Our Ref: BNE260439

20 November 2026

Application Reference:	A002135202
Property Location:	490 Boundary Street, Spring Hill QLD 4000
Property Description:	Lots 1-7 on Survey Plan 242888
Development:	**Request for s81 Minor Change -** (A002135202)
Applicant:	Body Corporate for "490 Consulting Suites @ St Andrew's" CTS50990

Figure 6 Planting Beds at the Front of the Lot

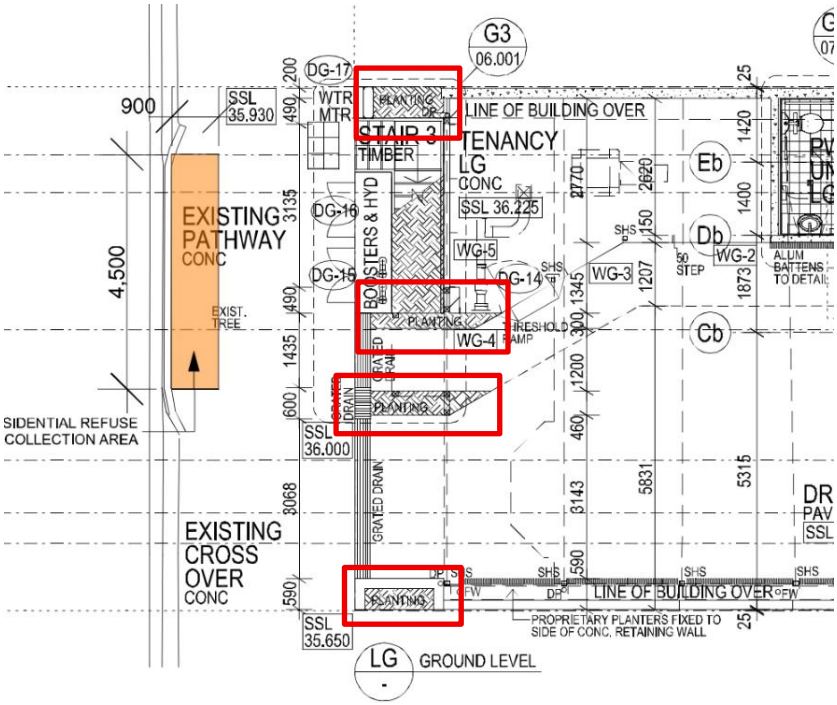
The two garden beds located furthest to the east of the site and below were unable to be provided due to the actual layout of the staircase to the retained building, requiring the staircase to extend further than shown in the plans. The planting area adjacent to the hydrant booster and sprinkler booster cages was unable to be delivered due to the necessary fire equipment being retained within the area behind the aforementioned cages and therefore requiring the space to remain unimpeded, as well as the existing stormwater grate and underground infrastructure within that section of the subject site required to remain accessible. The fourth garden bed at the site's western boundary has been mentioned previously in this application as being unable to provide any significant planting given the provided width of the retaining wall garden bed.

Given the existing state of the development, which cannot reasonably alter the built form without creating further issues regarding access and health & safety, portions of Condition 19 cannot be reasonably complied with and are to be altered accordingly, specifically the Planting section within Condition 19(c).
